**ADDENDUM
NO. 2**

Richland Bean Blossom Schools Roofing & Mechanical Renovations
Various Schools Locations
Ellettsville, IN 47429

PROJECT: Richland Bean Blossom – Roofing & HVAC
Junior High School

DATE OF ADDENDUM: February 10, 2026

1 ROOF DETAIL
N.T.S.

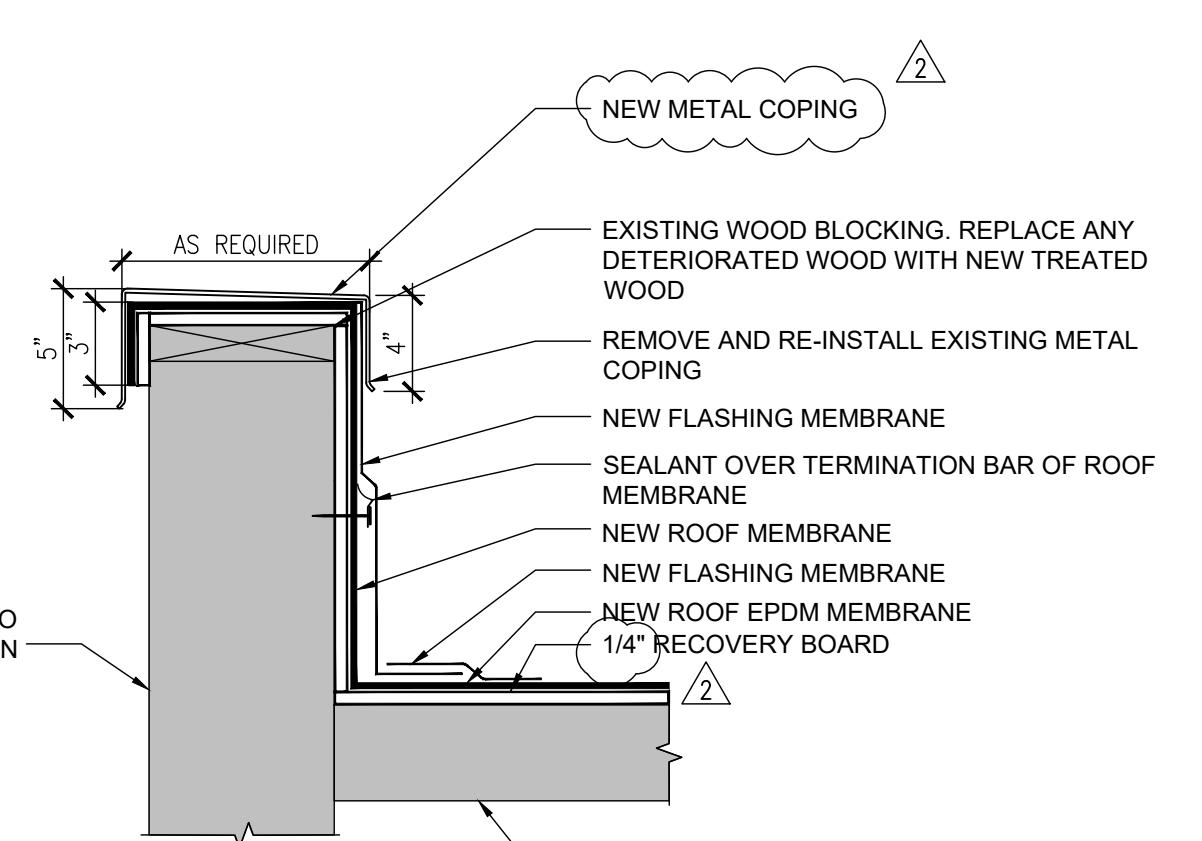
- All the recovery board shall be 1/4 inch thick.
- All parapet coping shall be new.
- New roof membrane shall be installed vertically and continue under the existing metal roof.

ROOF DETAILS

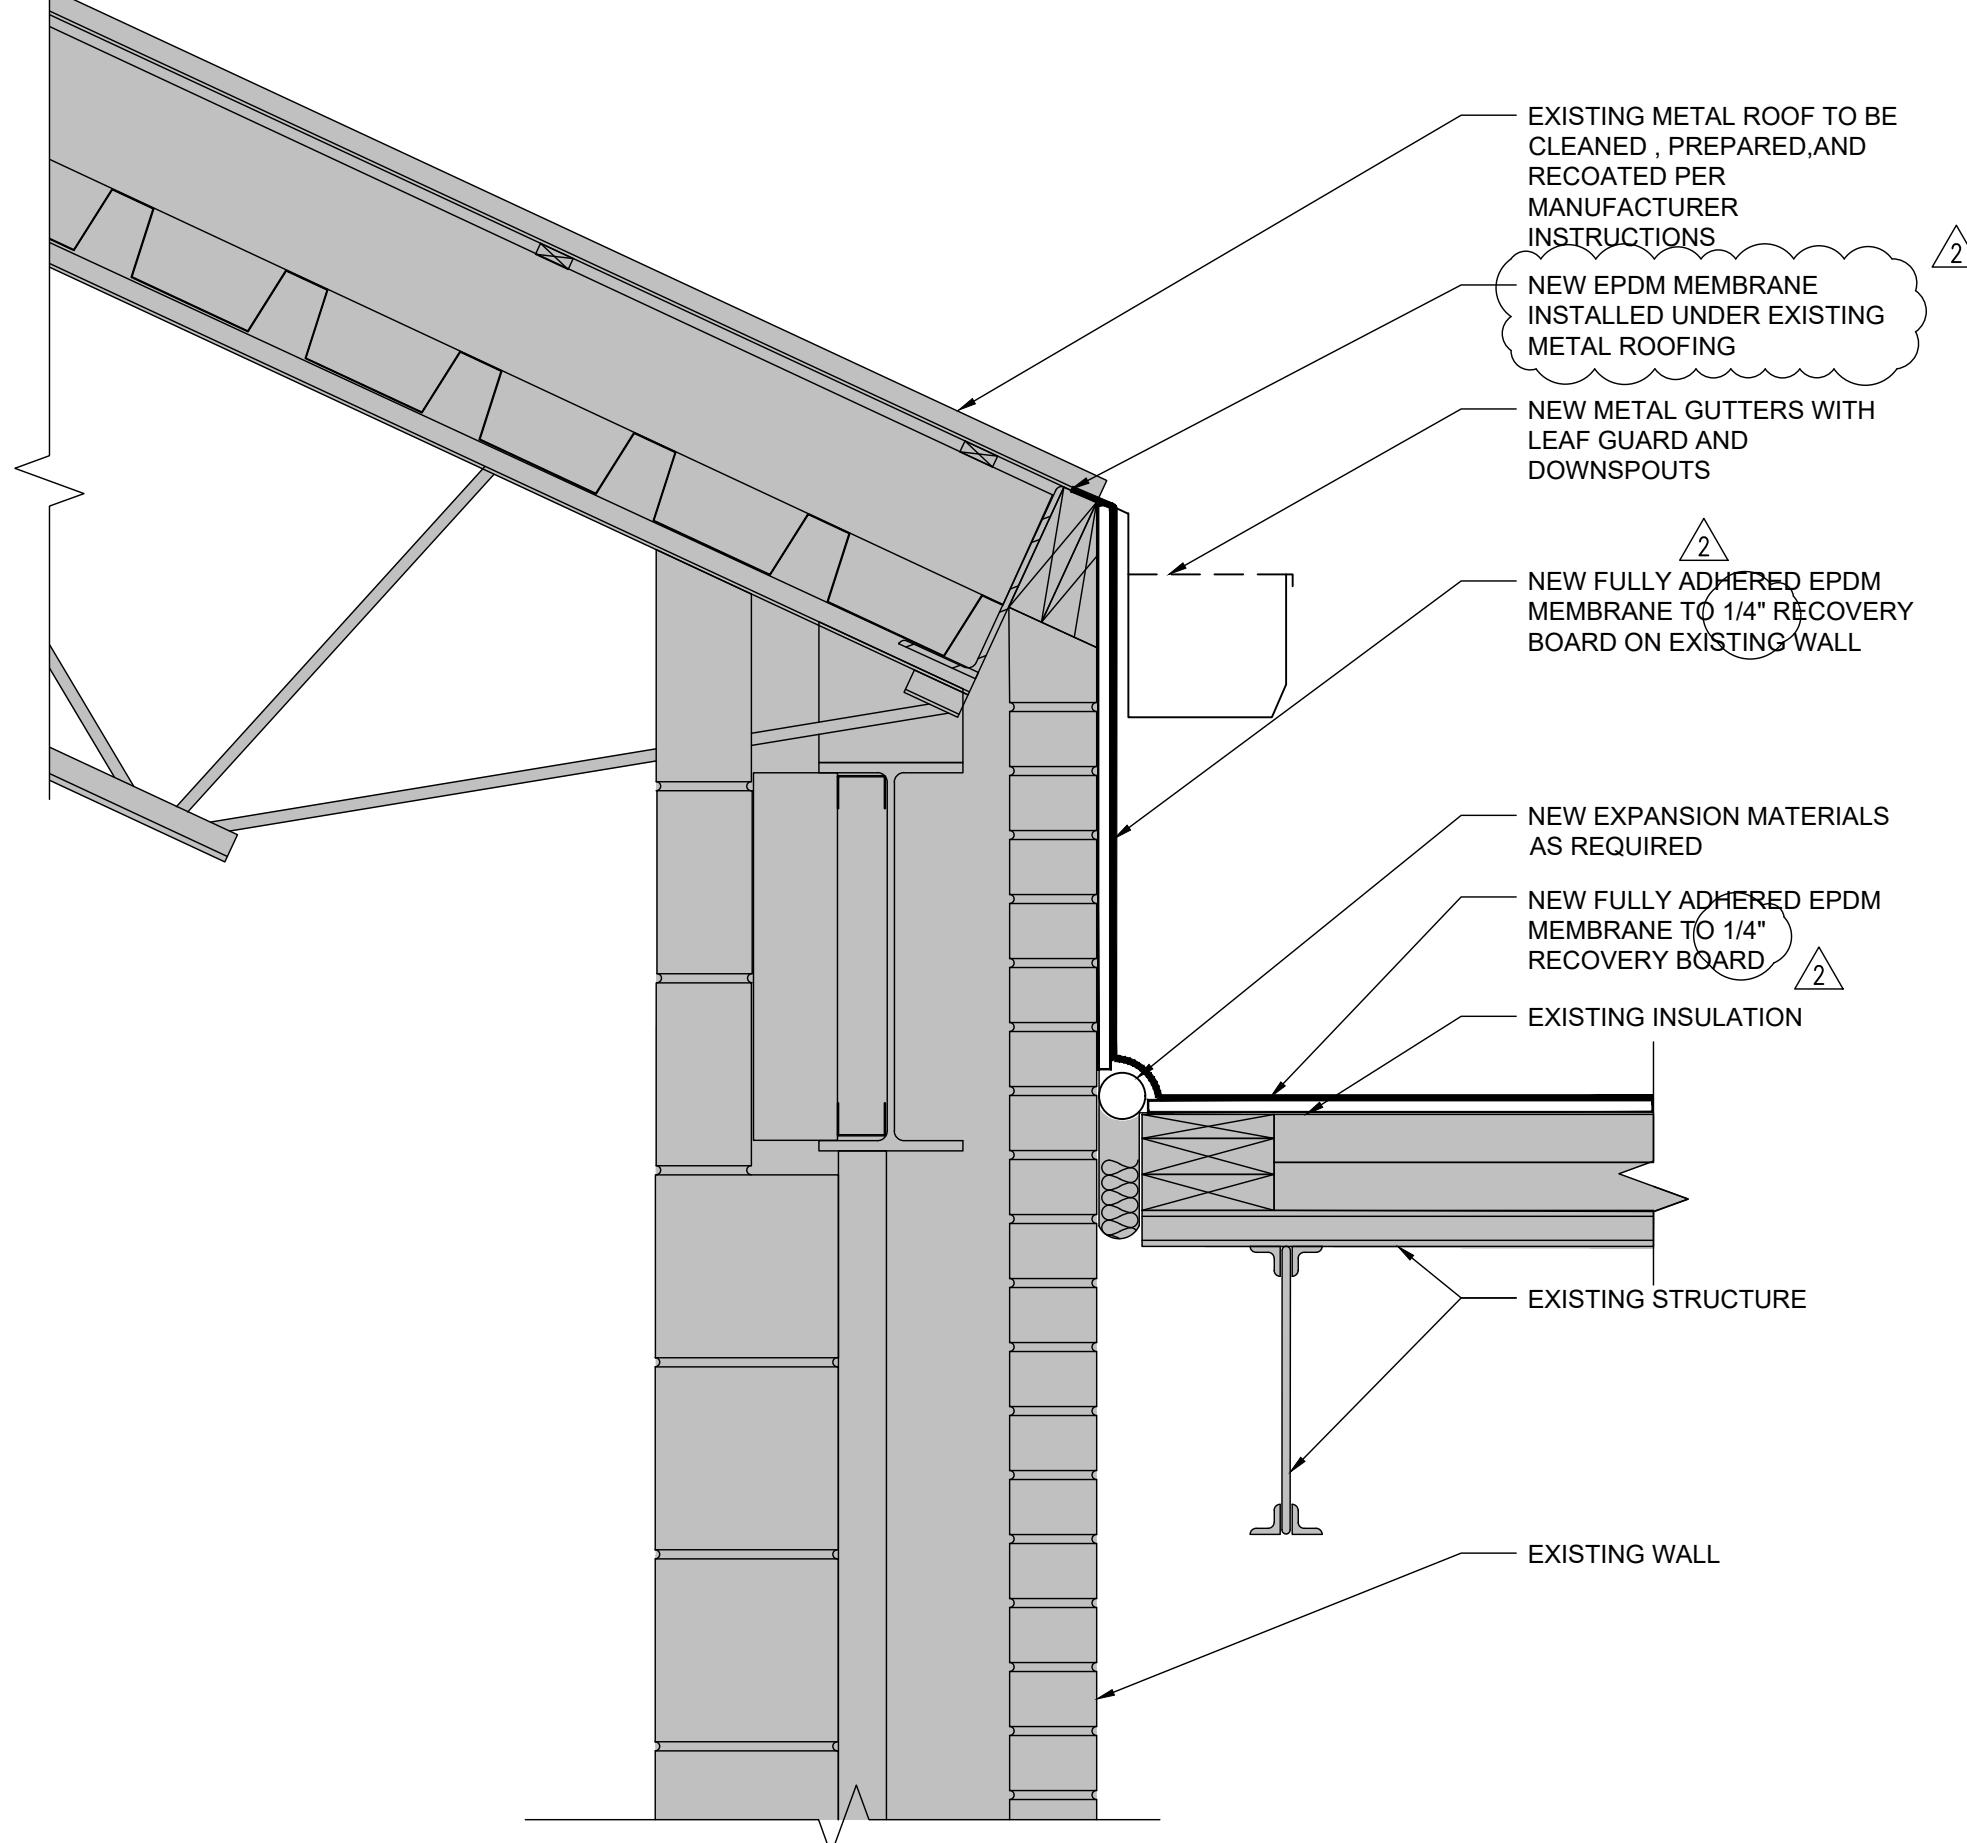
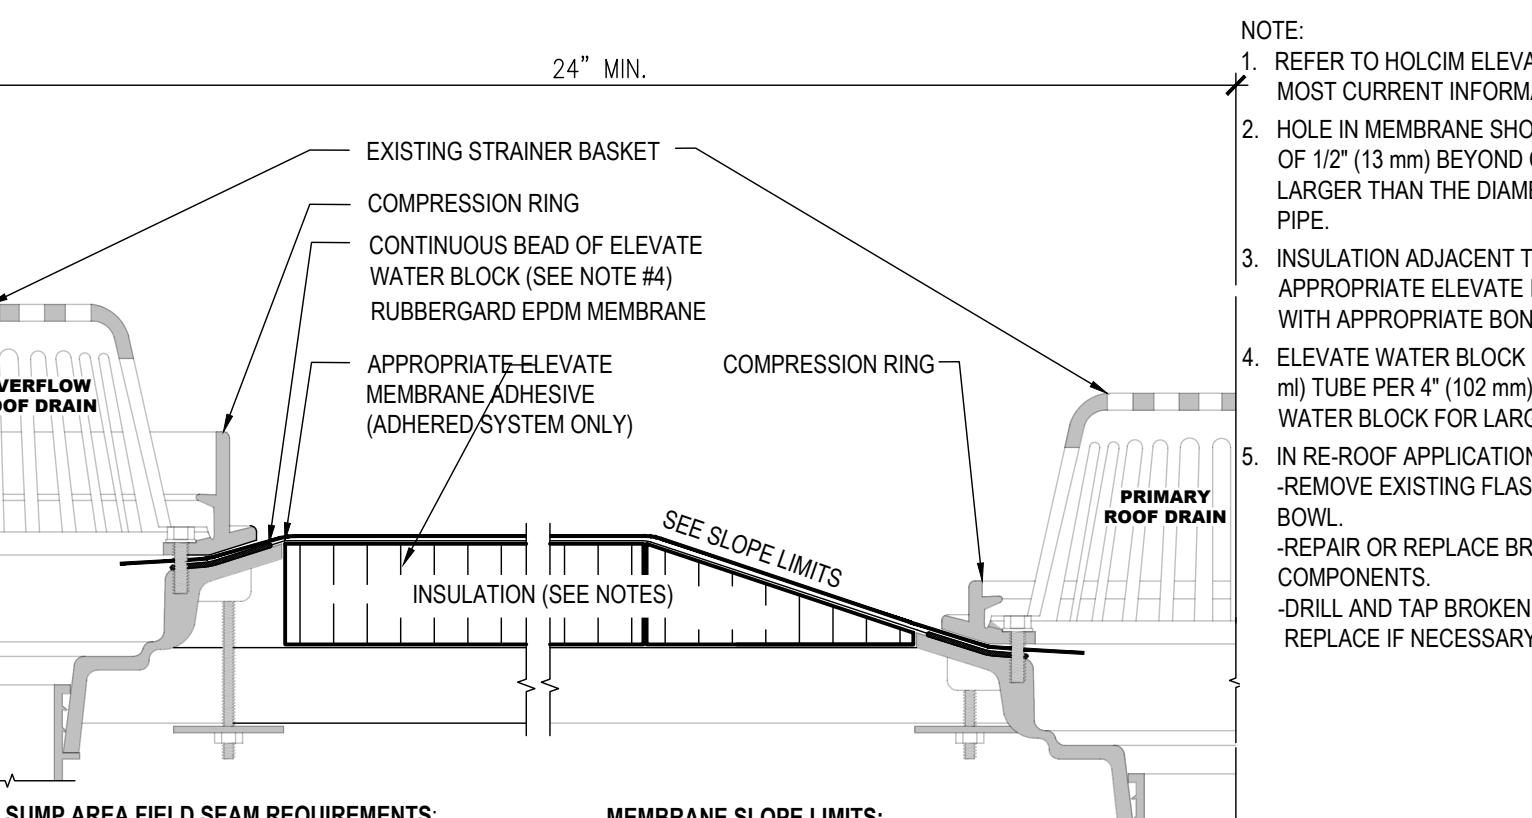
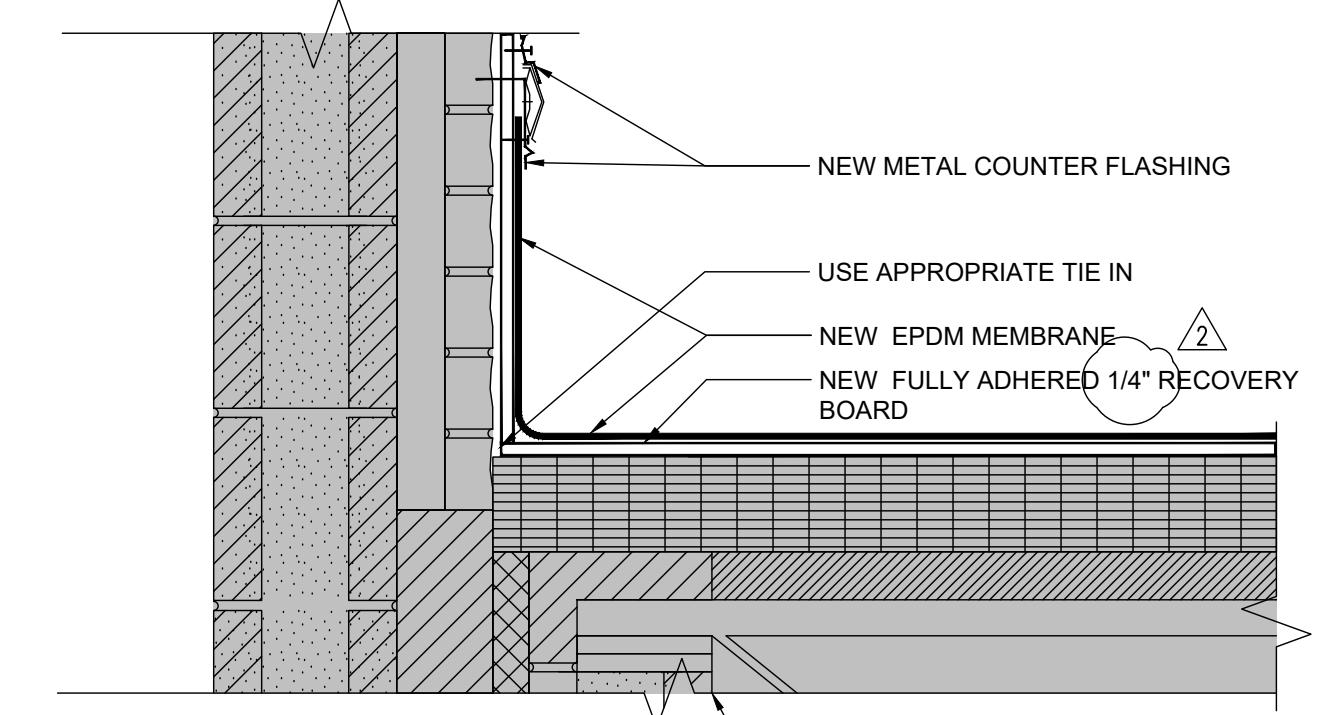
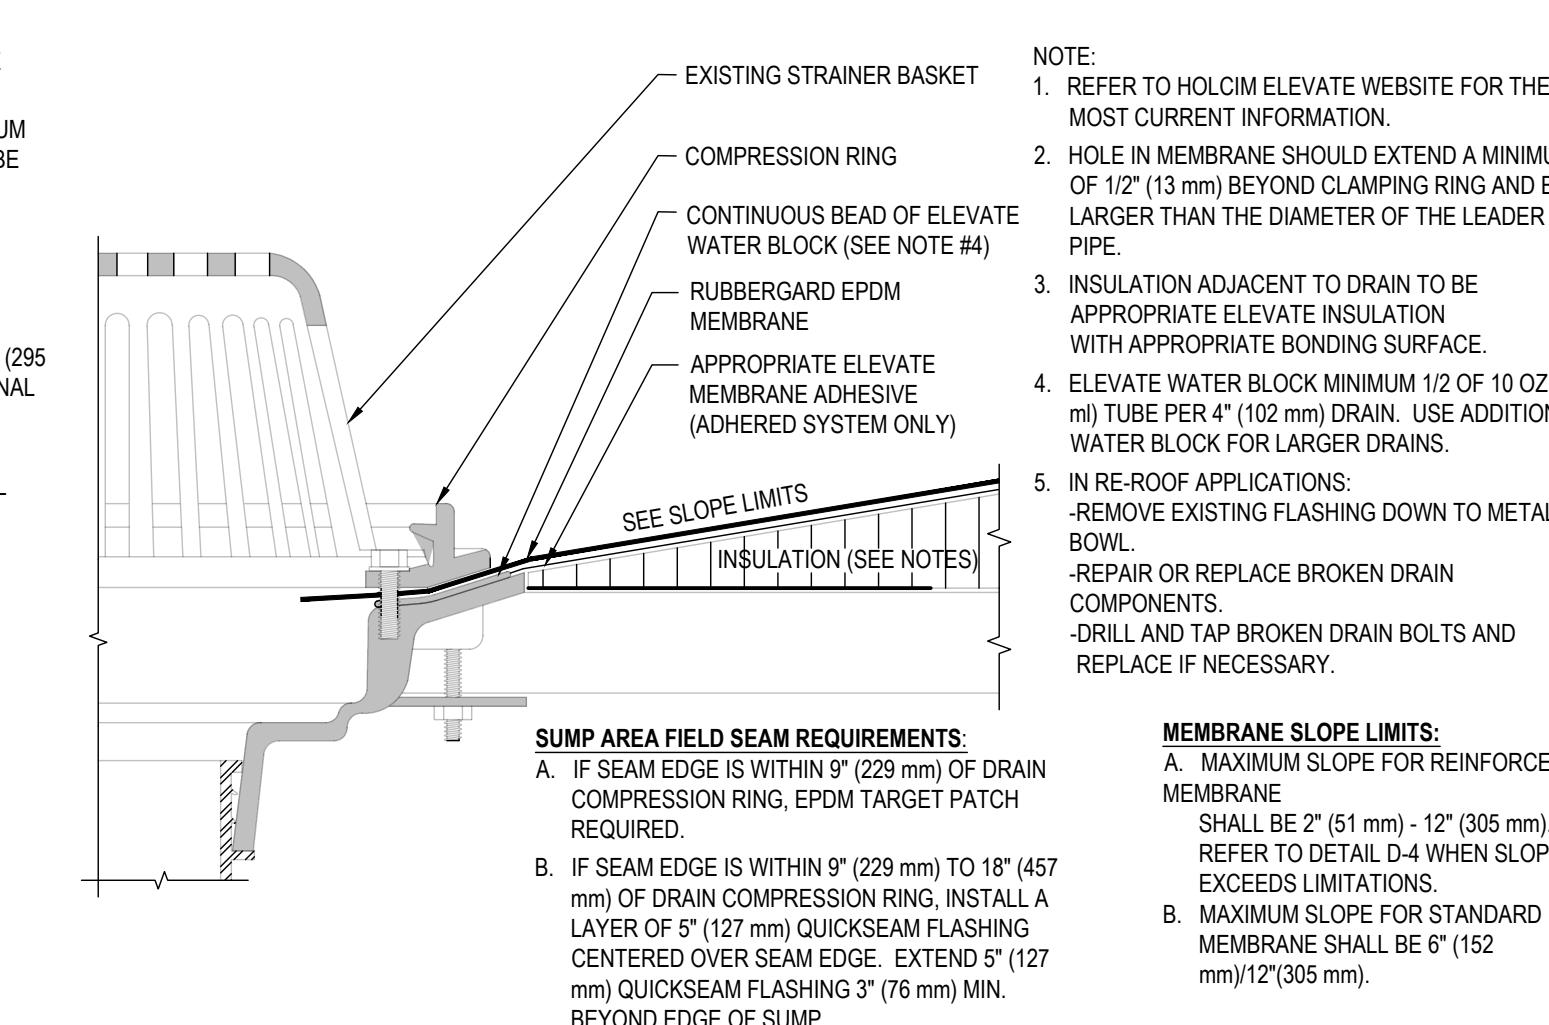
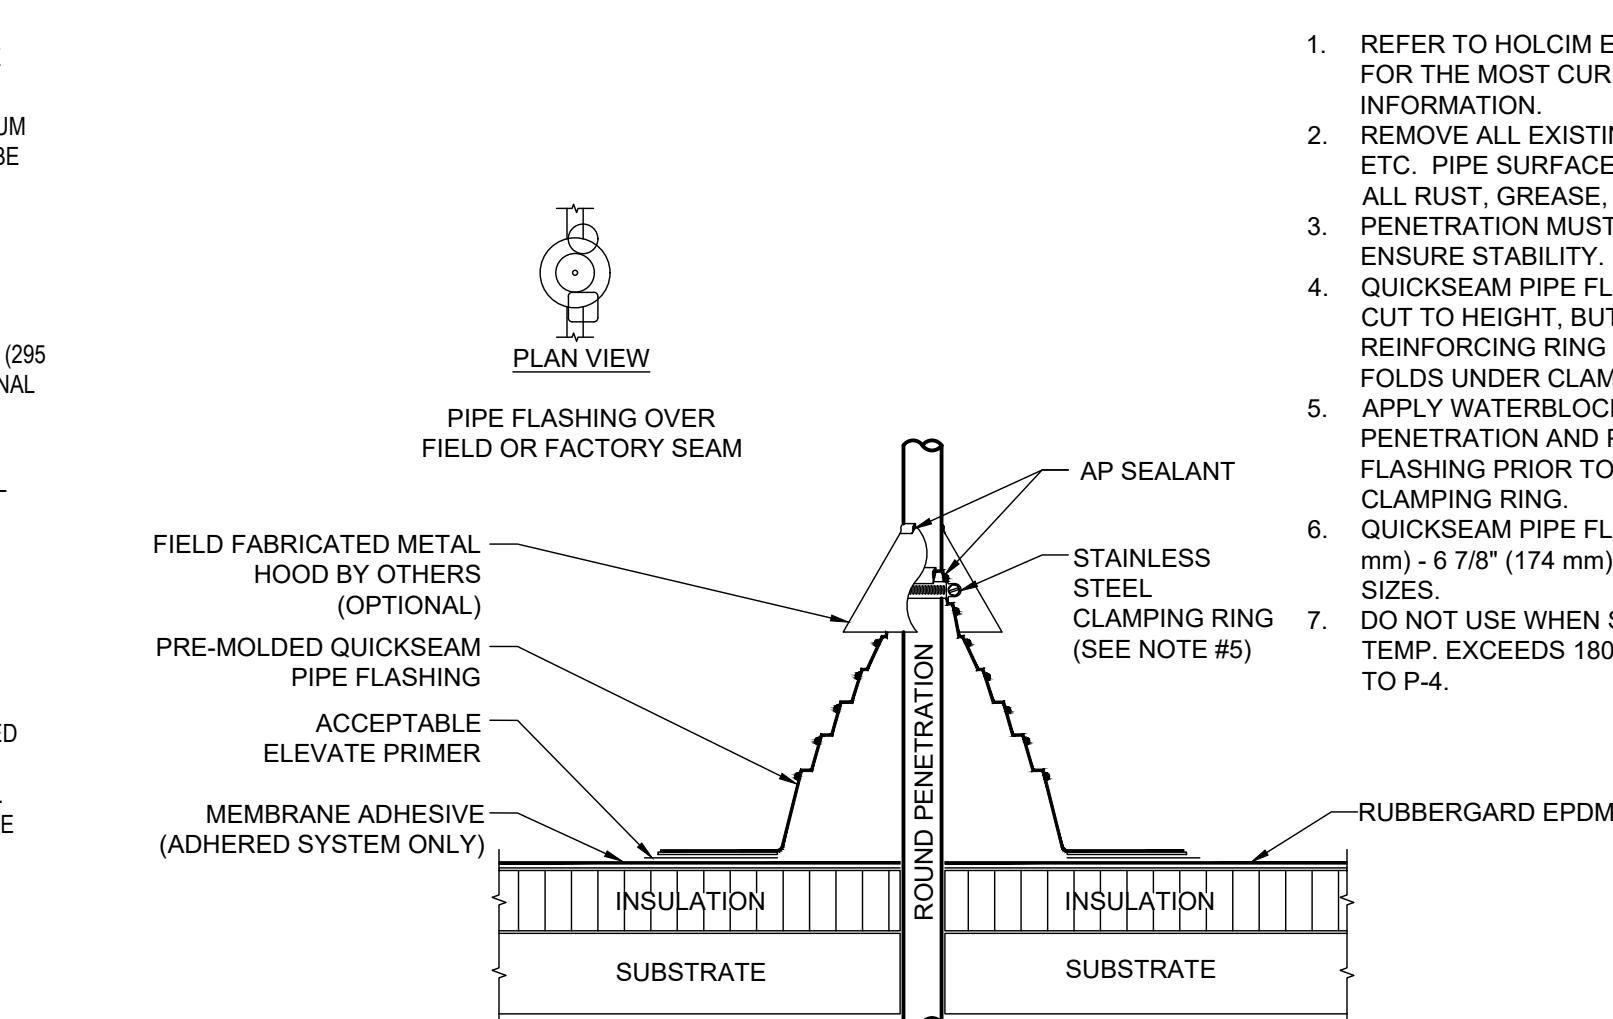
- All the recovery board shall be 1/4 inch thick.
- All parapet coping shall be new.
- New roof membrane shall be installed vertically and continue under the existing metal roof.
